NEW BRITAIN - HARTFORD BUSWAY

PERMITTING SUBMISSION

SIGOURNEY STATION

**BRT Station Preliminary Drainage Design
DOT Report**

TOWN:
HARTFORD
DRAWING TITLE:
**SIGOURNEY STATION
DRAINAGE PLAN**

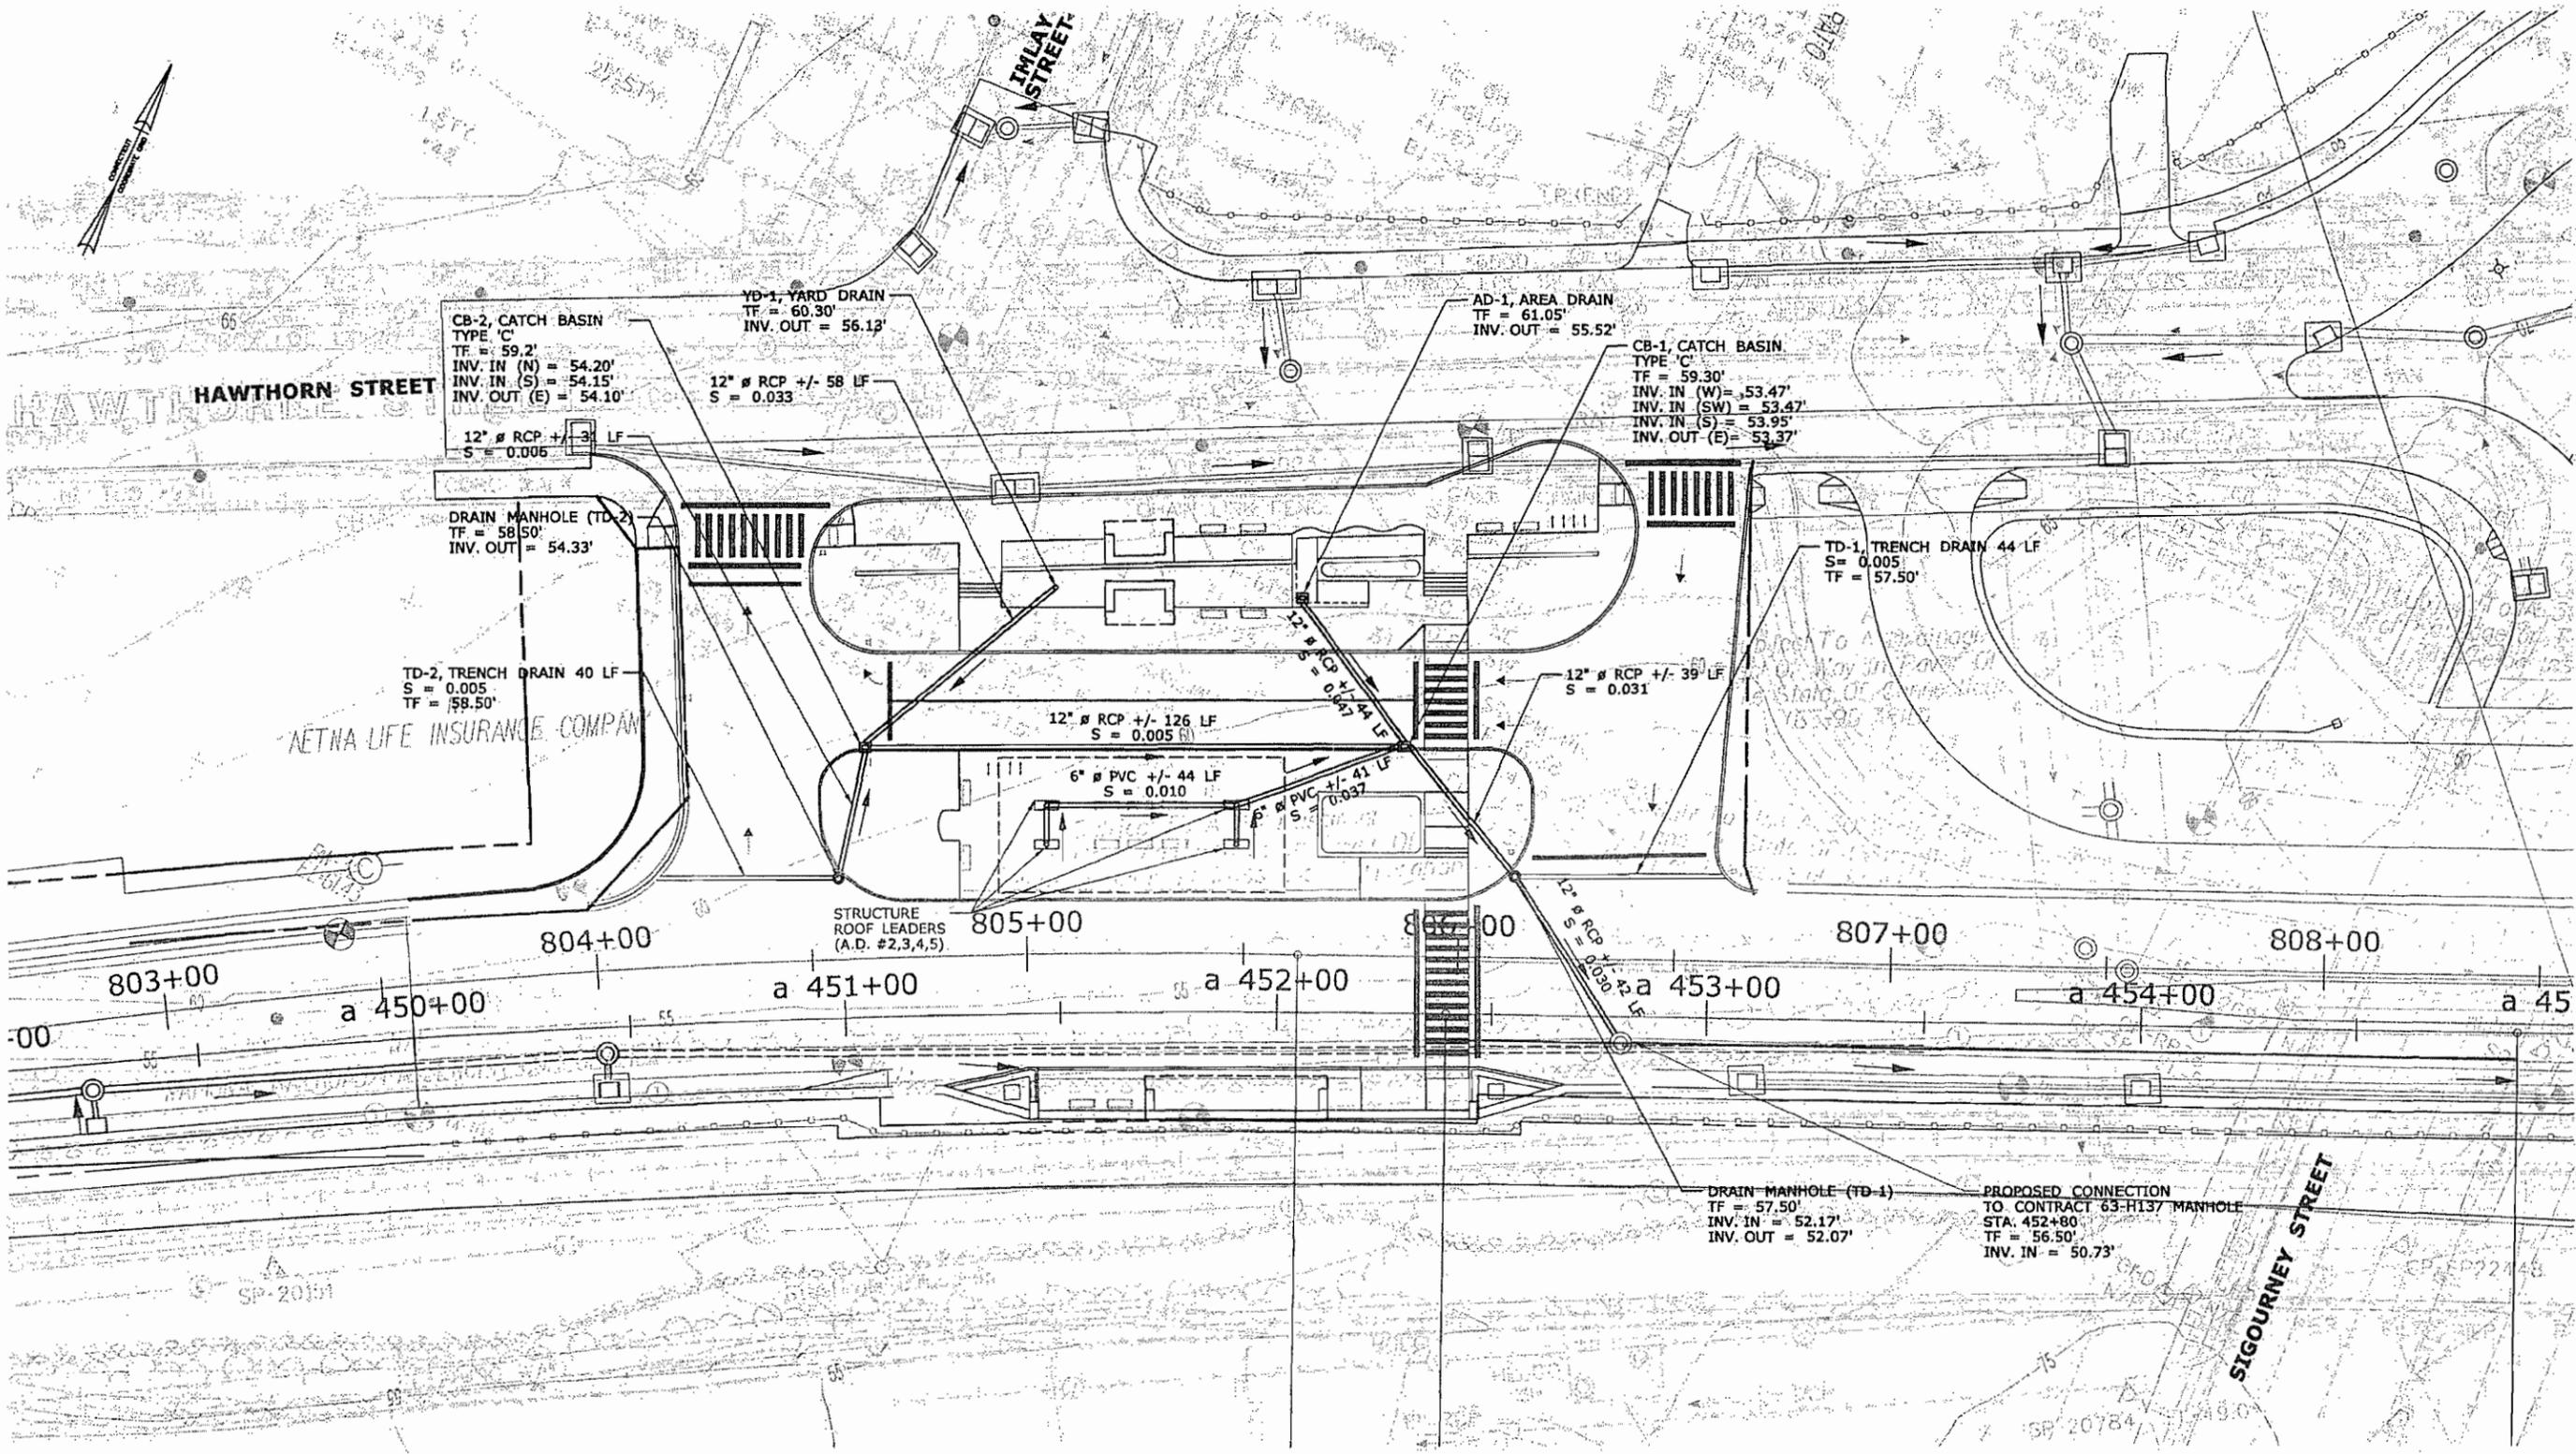
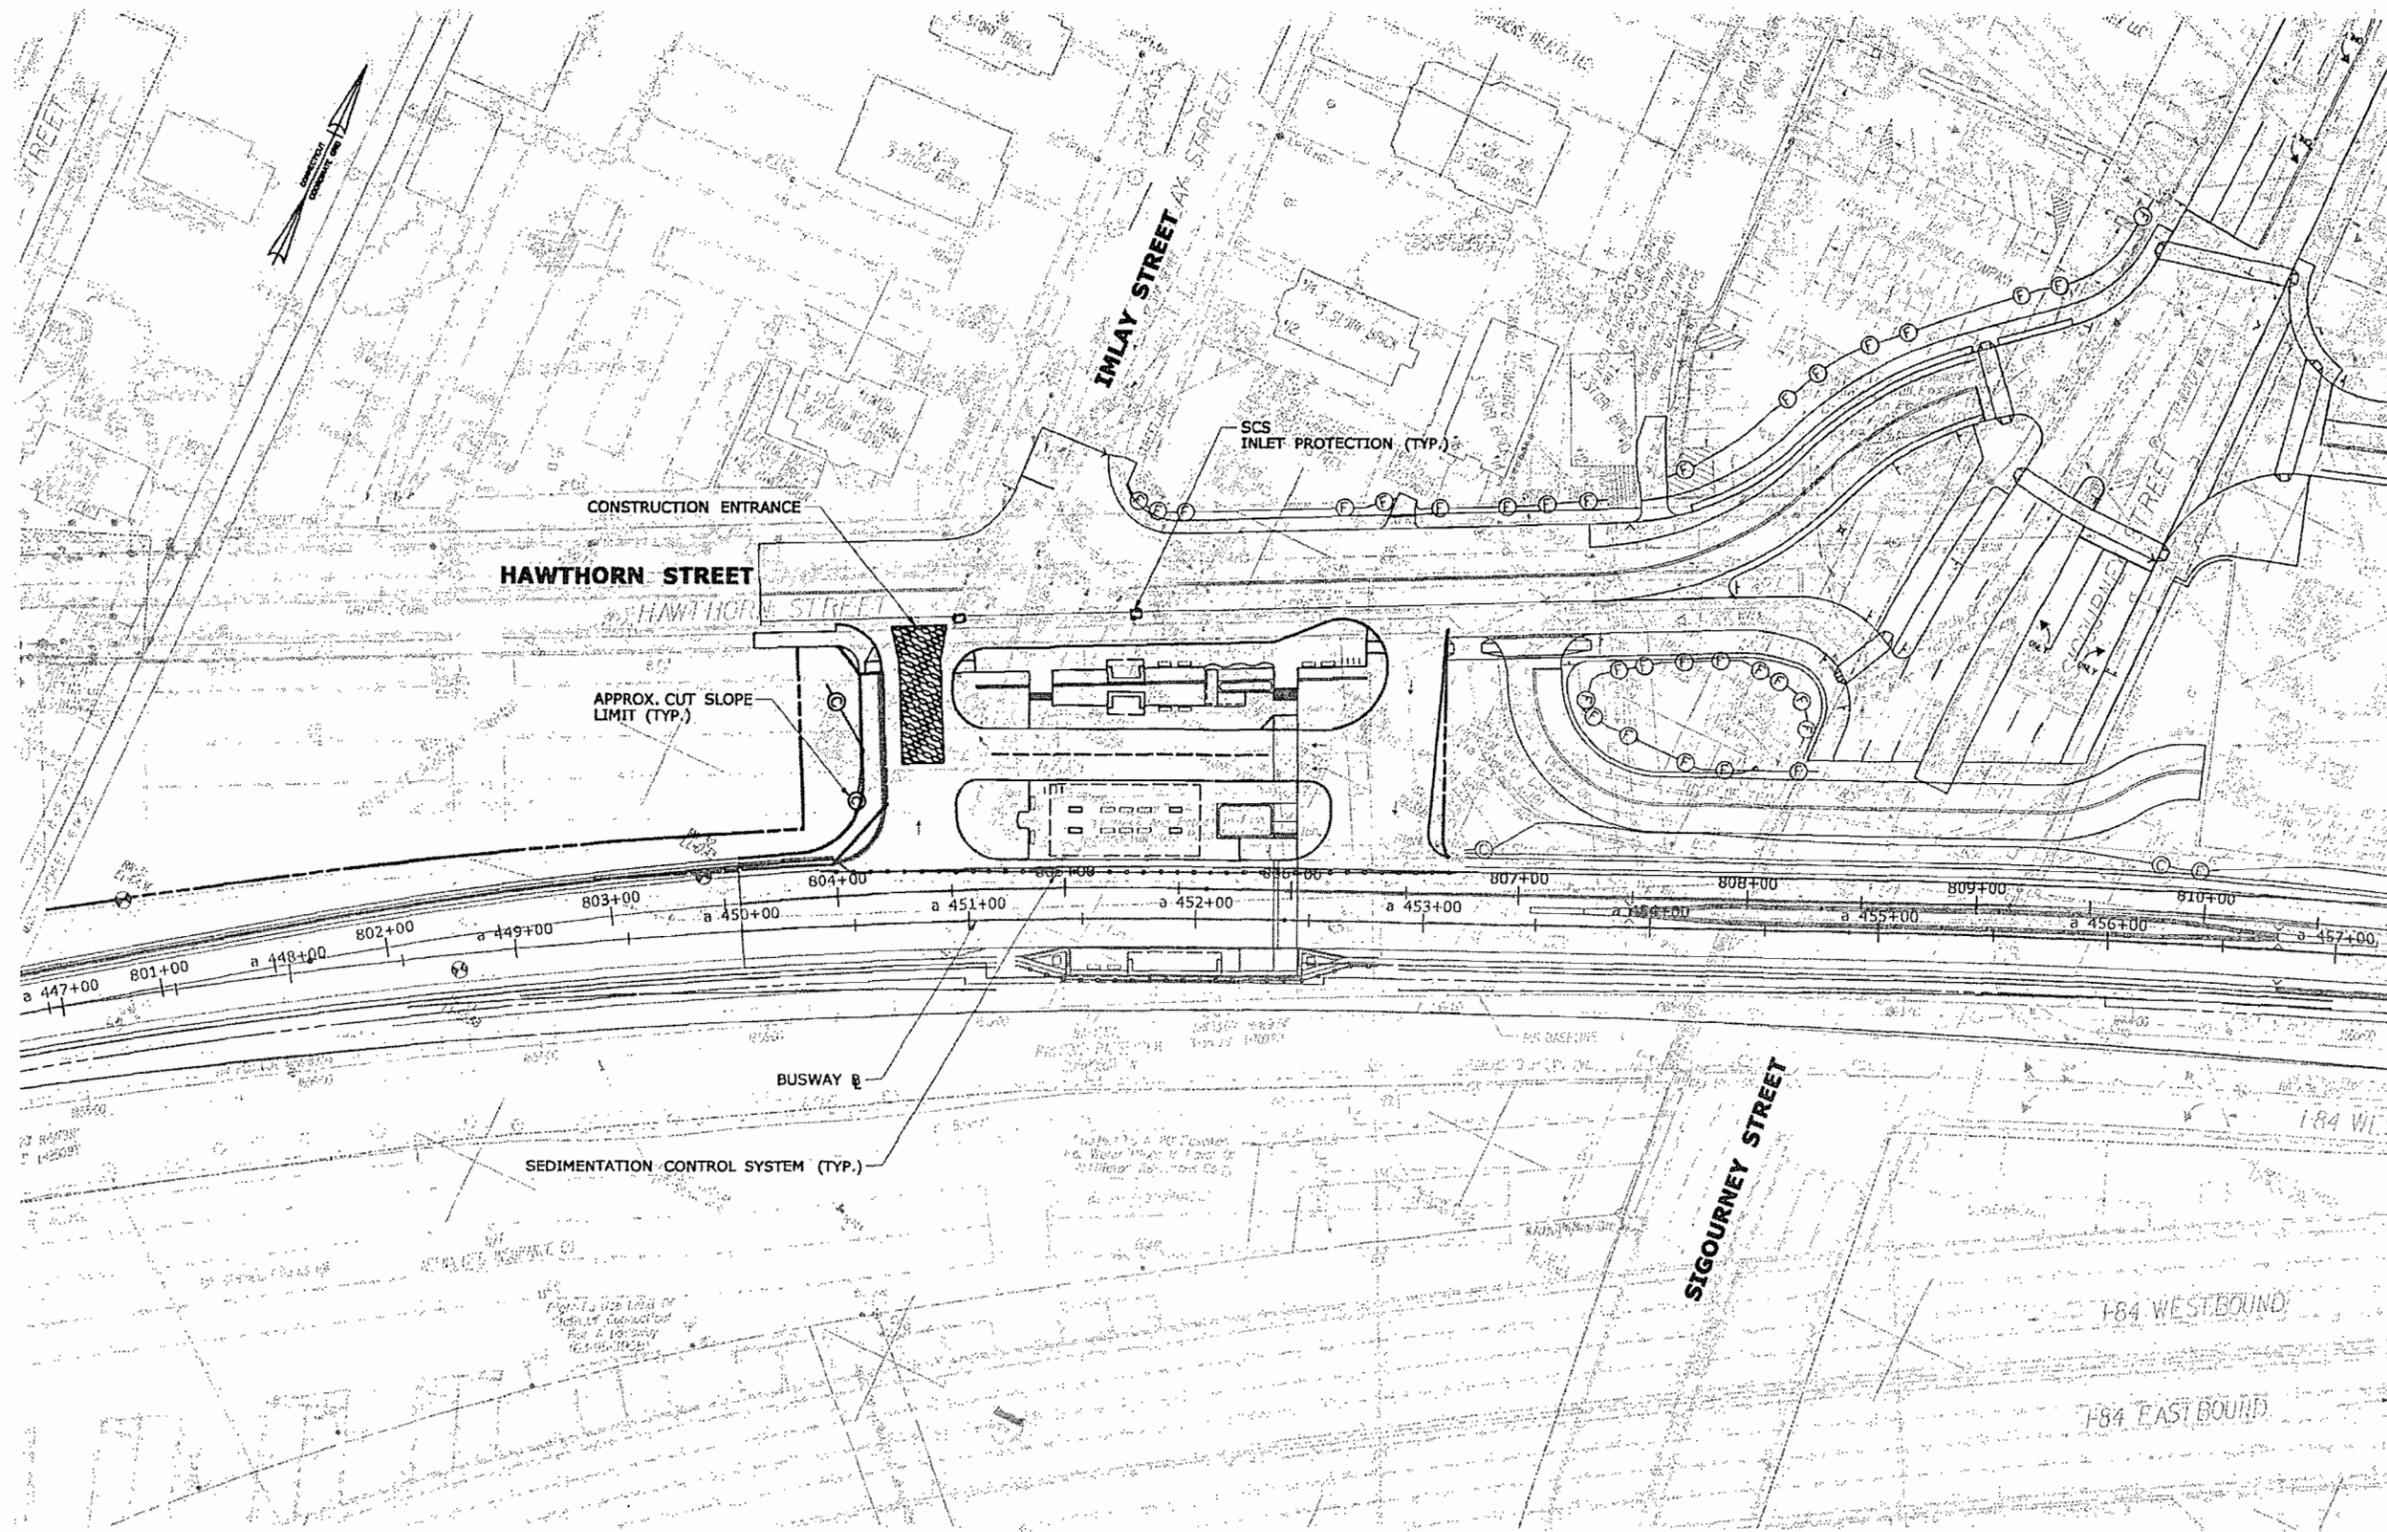
No.	Comment	Inc.	Not Inc.
1	A yard drain (YD-1) and an area drain (AD-1) are proposed at the western limits of the station. Both are located in grass areas and will collect very small runoff (.07 cfs and .04 cfs respectively). In addition, trees are proposed at these locations and will make the inlets prone to clogging. Consider regrading these areas to eliminate the low spots and allow runoff to discharge onto the pavement. This will eliminate several drainage structures and unnecessary storm drainage pipe.		
2	Two trench drains are proposed on the east side of the station driveways to capture runoff before it discharges to the busway mainline. Trench drains are prone to collect sand and sediment during normal conditions and especially during sanding operations in the winter. Consider installing standard catch basins on each side of the driveway pavement in lieu of the trench drains. Catch basins will be more effective in collecting the pavement runoff and be more conducive to future cleaning and maintenance.

The proposed contours and spot elevations show that a low point is created in front of the station crosswalk that leads to the northbound busway platform without provision for an inlet. How will this low point drainage be intercepted? Double check other areas to avoid ponding problems.

The drainage plan depicts "clean water" (underdrain and yard drain) being added into the stormwater system. This unnecessarily adds to the volume of stormwater which must be treated. Please investigate keeping clean water discharges separate.

S E A Response: The Area Drain (AD-1) is located to collect runoff on the handicap access ramp. It is designed to minimize icing conditions on the ramps and improve safety. The Yard Drain (YD-1) is located to minimize runoff over the plaza and pedestrian areas also to minimize icing potential.

S E A Response: The curb line in front of the northbound busway platform is sloped to drain from north to south (as designed by Contract 63-H137). The busway cross section is superelevated here from west to east (southbound platform to northbound platform). No low points are shown on the grading plan. Drainage in this area will be collected by an inlet proposed by the mainline near Station 453+10.

S E A Response: *The station drainage system includes collection from one yard drain (YD-1) and roof leaders from the large busway canopy on the southbound platform. No underdrains are proposed. The station site is restricted by the limited footprint and operational requirements and does not allow for an alternative discharge location for these flows.*
